Re: S/D 86-12 - Final Plat of Rock Park Second Addition.

ROCK PARK SECOND ADDITION

FINAL PLAT

S/D No.: 86-12 Name: ROCK PARK SECOND ADDITION

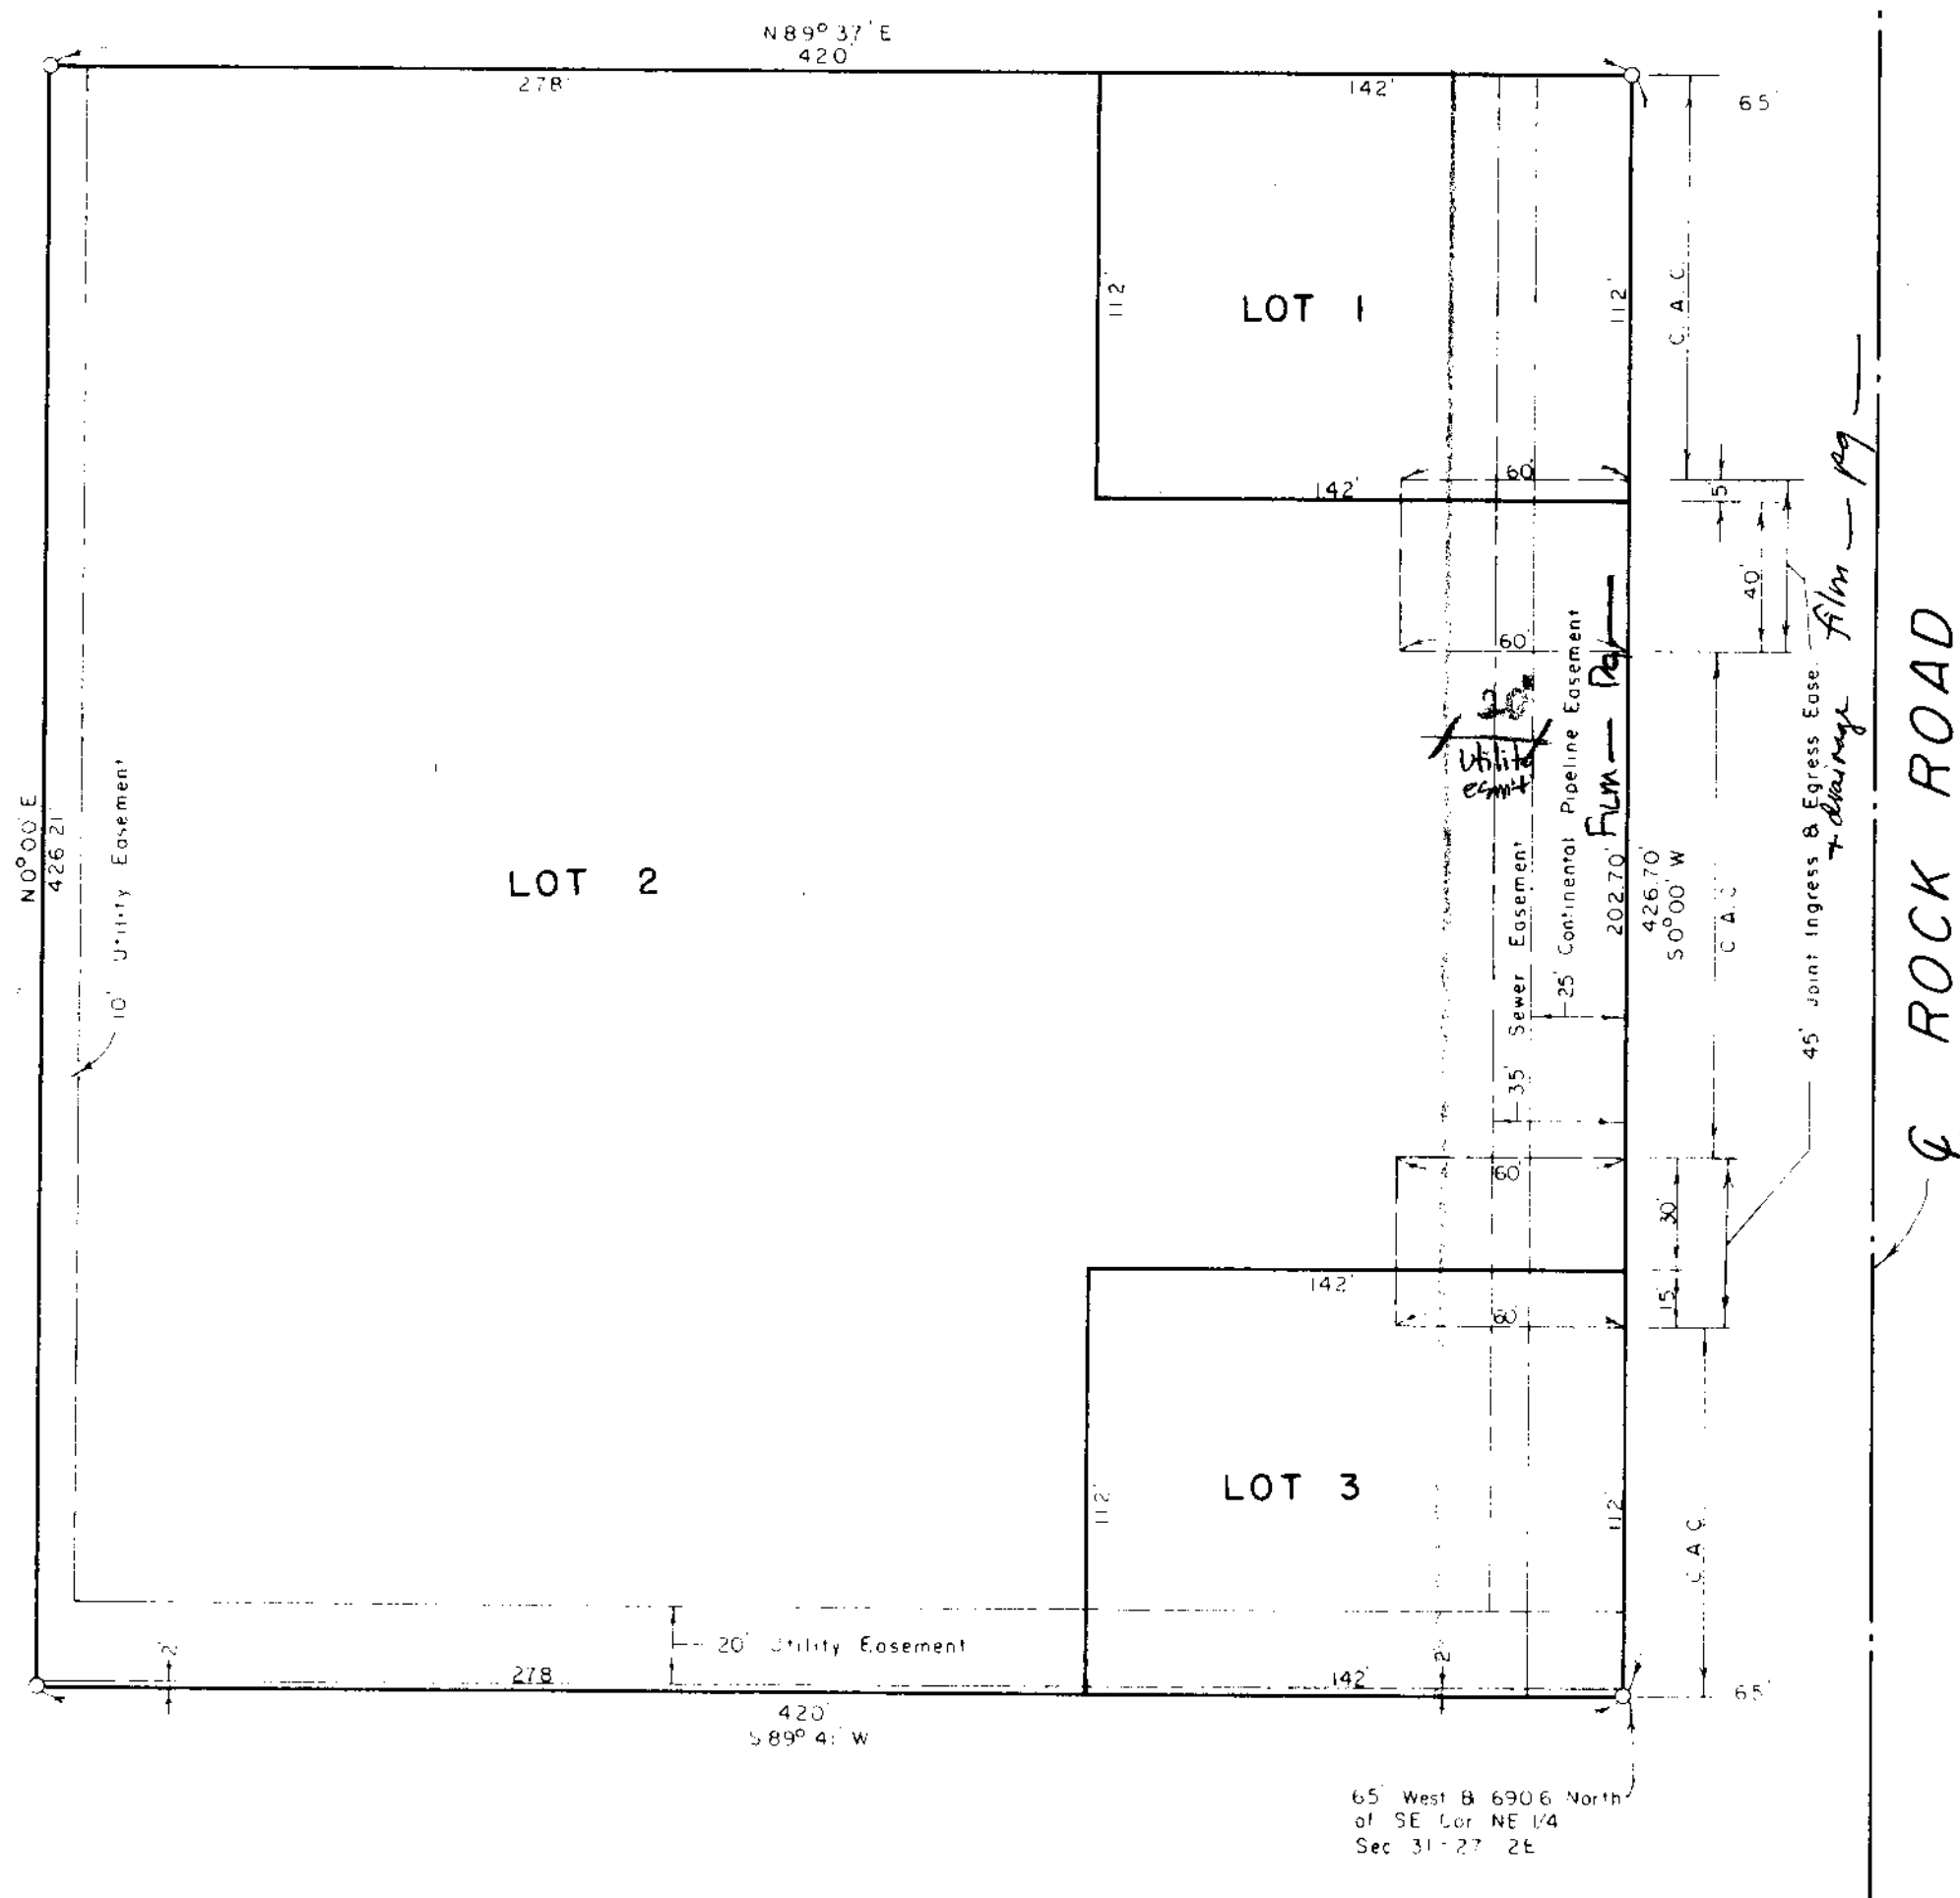
- H. Proof shall be submitted as to which partners comprising the partnership must execute documents on behalf of the partnership (e.g., copy of partnership agreement or certification from a title company).

- I. The applicant is advised that the Community Unit Plan prohibits development of this property with any use not mentioned in Item No. 8 of the C.U.P. Restaurants are not permitted by the Community Unit Plan and, if the applicant desires to construct restaurants on this property, the C.U.P. must be amended.

- J. Perimeter closure computations shall be submitted with the final plat tracing. Section 5-101(C).
- K. Recording of the plat within 30 days after approval by the Board of City Commissioners.

- L. The representative from the City Engineer's office should be prepared to comment on the status of the applicant's drainage plan. Specifically, are any drainage guarantees required by this replat?

- A.** The applicant shall guarantee the extension of sanitary sewer to serve the lots being platted.
- B.** The applicant shall guarantee any drainage improvements required by the platting of this property.
- C.** If improvements are guaranteed by petition, a notarized certificate listing the petitions shall be submitted to the Planning Department for recording.
- D.** On the final plat tracing, the wording in the platlor's text shall be amended to more clearly reference the access control being granted and shall state that the permitted openings to Rock Road shall be determined by the City Engineer. The following wording is suggested:

"All abutter's rights of access to or from Rock Road over and across the east line of the plat, except at the location of the joint ingress/egress easements shown on the face of the plat, are hereby granted to the City of Wichita, Kansas. The location of the one (1) permitted driveway within each of the two access easements shall be determined by the City Engineer.

- E.** The proposed 45-foot joint ingress and egress easements to serve Lots 1 and 2, and Lots 2 and 3 will need to be established by separate instrument with appropriate recording information indicated on the final plat tracing. Prior to recording the joint access easement, a draft shall be submitted to the Planning Department for review and approval. The instrument must clearly state the purpose of the easement, as well as which properties benefit from the easement. Initial construction responsibilities and future maintenance of the driveway within the easement should also be addressed by the text of the instrument.

- F.** Since existing access control to Rock Road is being vacated by this replat, the final plat tracing shall make reference to the vacation of access controls by virtue of K.S.A. 12-512(b).

- G.** The final plat tracing shall reference, on the face of the plat as well as in the platlor's text, that building setbacks are per the requirements of the Rock Road Commercial Community Unit Plan (DP-84) on file with the Wichita-Sedgwick County Metropolitan Area Planning Department.
